Planning Commission Meeting Agenda

6.I. Site Plan (Revision) – (ST1615) Advanced Interiors – 6656 Pine Ridge Ct.

(ST1615) Advanced Interiors, 6656 Pine Ridge Ct., is requesting approval of a revision to an approved site plan to allow a dumpster to be located in a truck well with no screening, on a parcel of land described as P.P. # 70-14-22-477-004, located at 6656 Pine Ridge Ct., in an (I) Industrial district, Georgetown Township, Ottawa County.

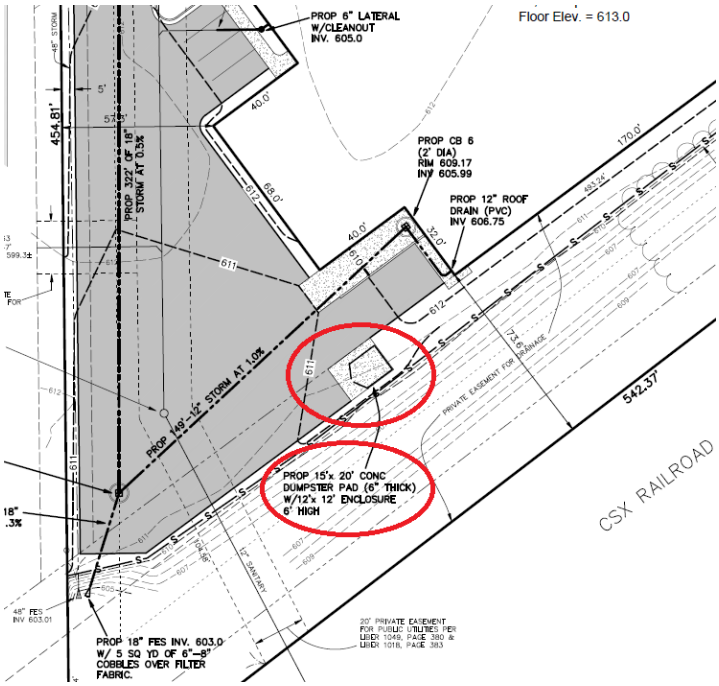
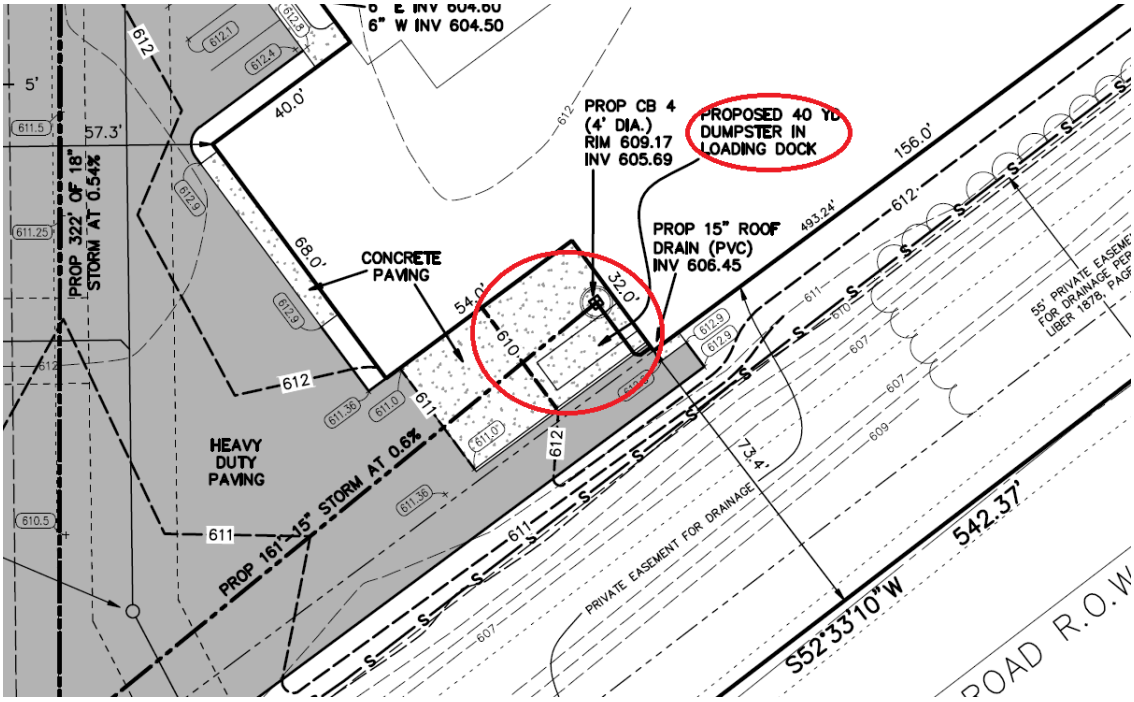
At the November 5, 2014 meeting, the Planning Commission approved a special use permit and site plan showing the dumpster to be located on a cement pad and enclosed with a six foot high fence.

The request is to locate the dumpster in the truck well and to have no screening.

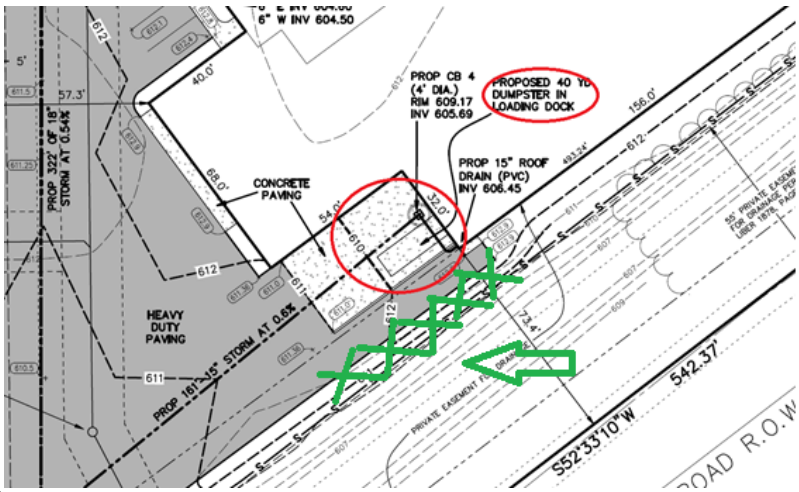
Although the Zoning Ordinance gives the Zoning Administrator the authority to approve site plans and to approve minor changes, the determination was made that this change should return to the Planning Commission since the Planning Commission initially approved the site plan that was part of the Special Use Application. Further, the approved the site plan with the dumpster on a cement pad and with screening, was based on the language in the ordinance. Therefore, the Planning Commission should determine if the new location is appropriate and if it should be allowed with no screening.

The Zoning Administrator offered to approve the new location with screening (either six foot high fencing or landscaping) to be added along the outside of the lane as shown in the drawing above. However, the applicant stated that the area is not visible from Chicago Dr. due to a berm that is covered with weeds that screens the site and is, therefore, requesting no screening.

SIGHT-LINE CROSS SECTION

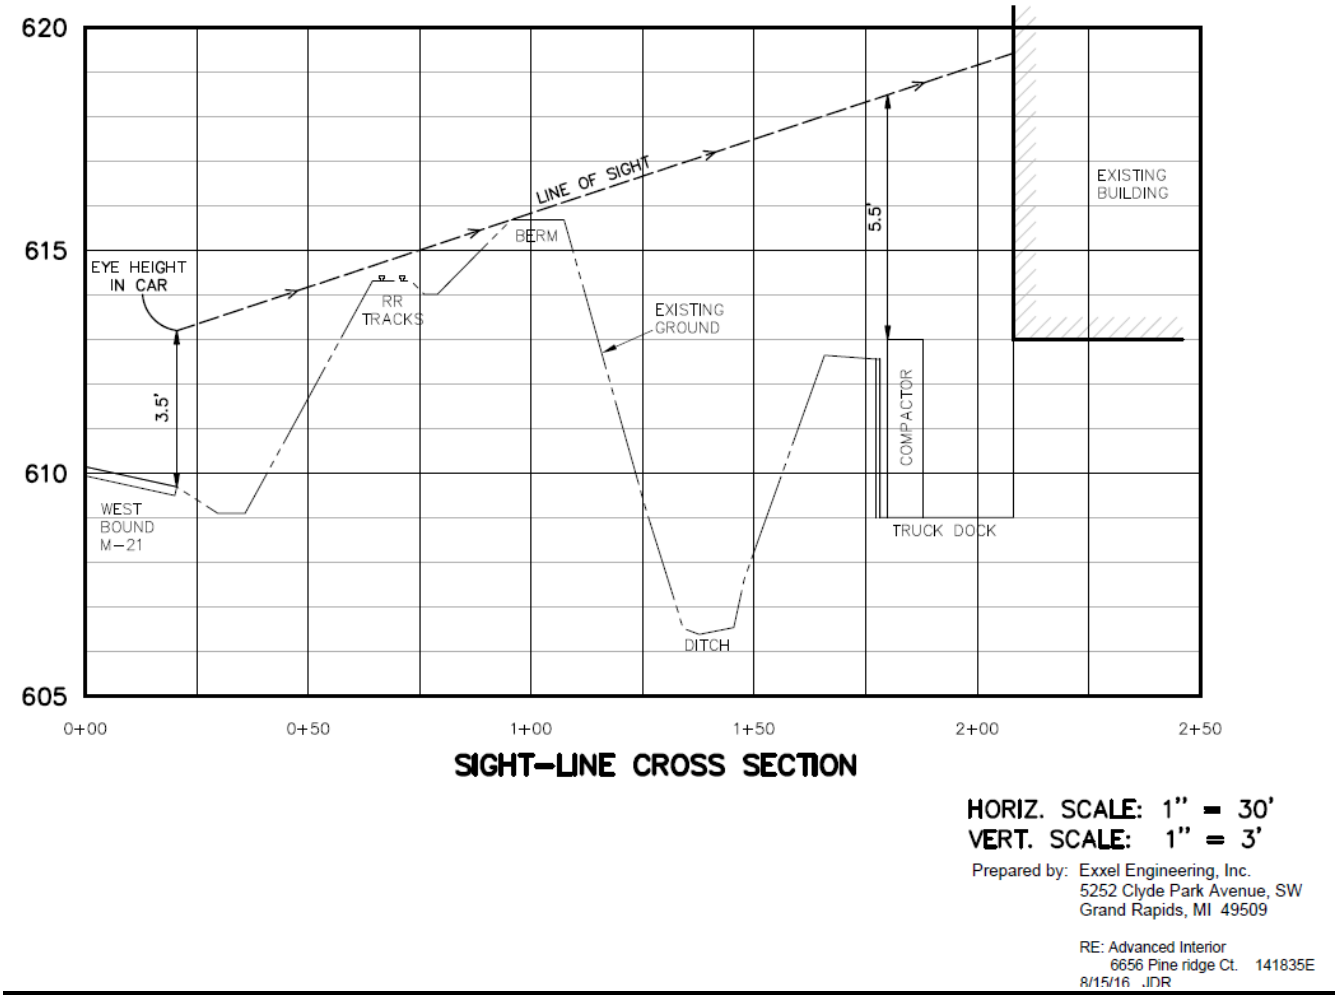
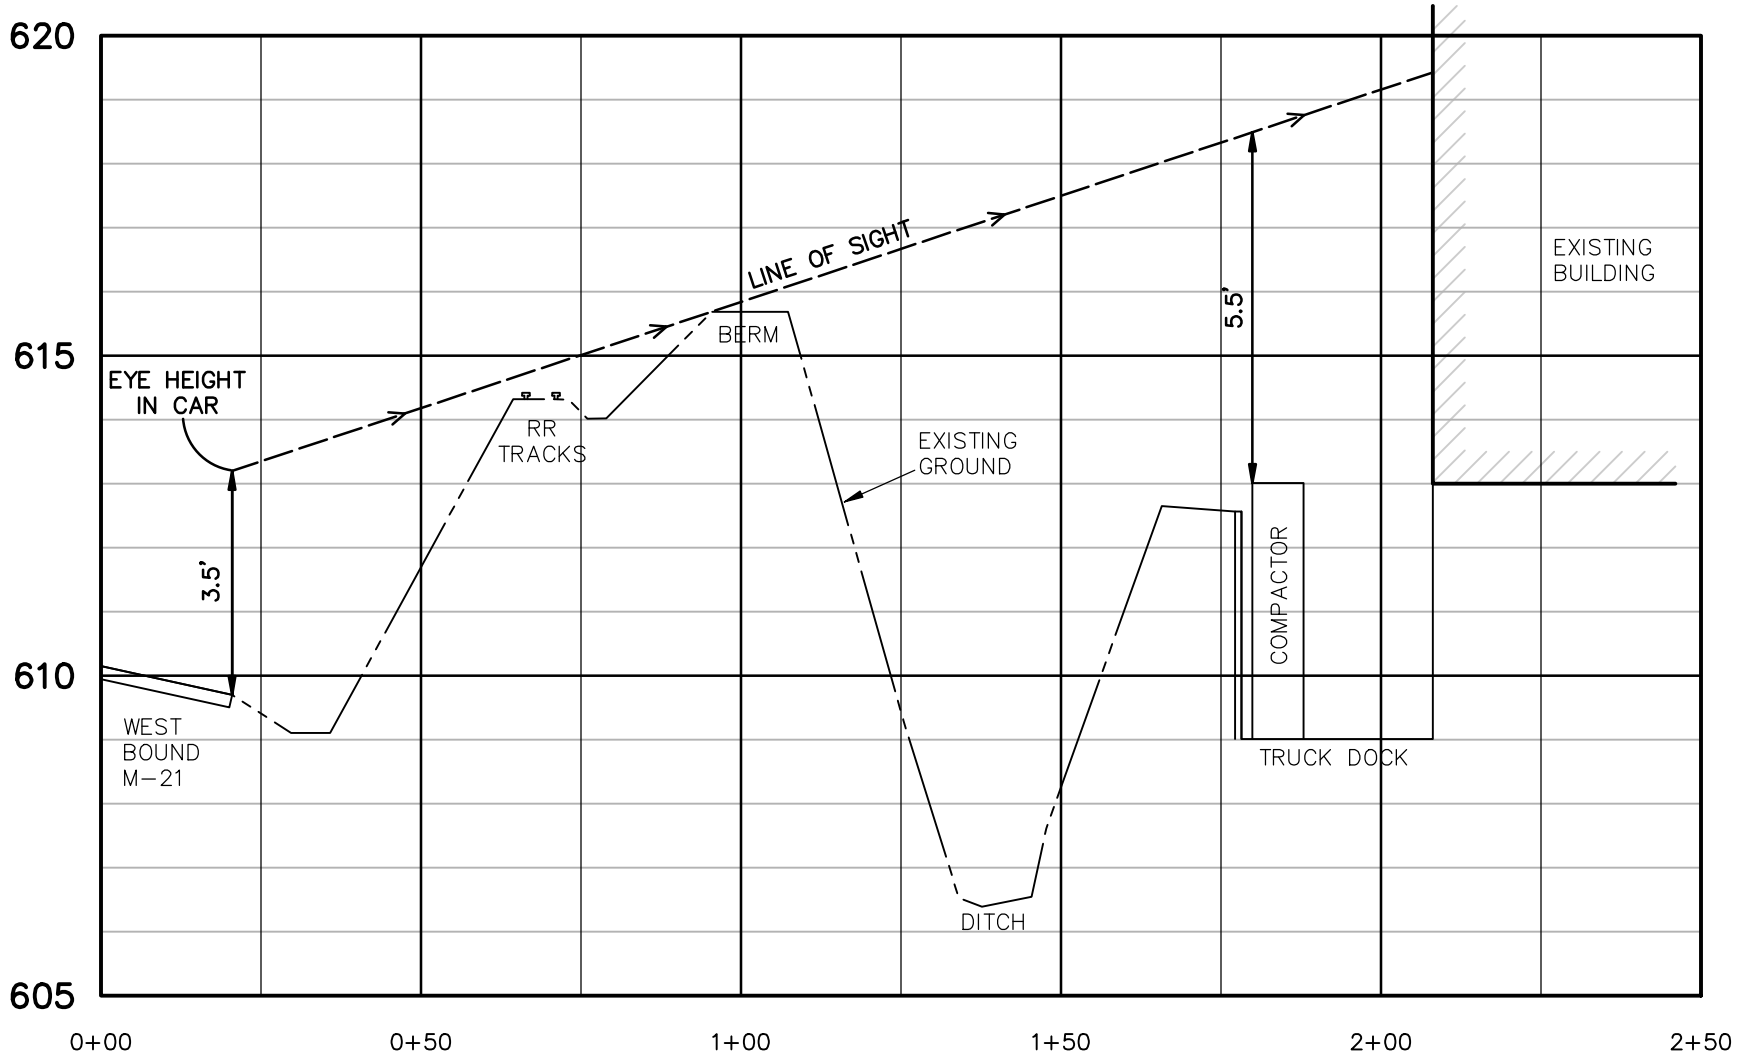
Below is the line of sight submitted by the applicant.
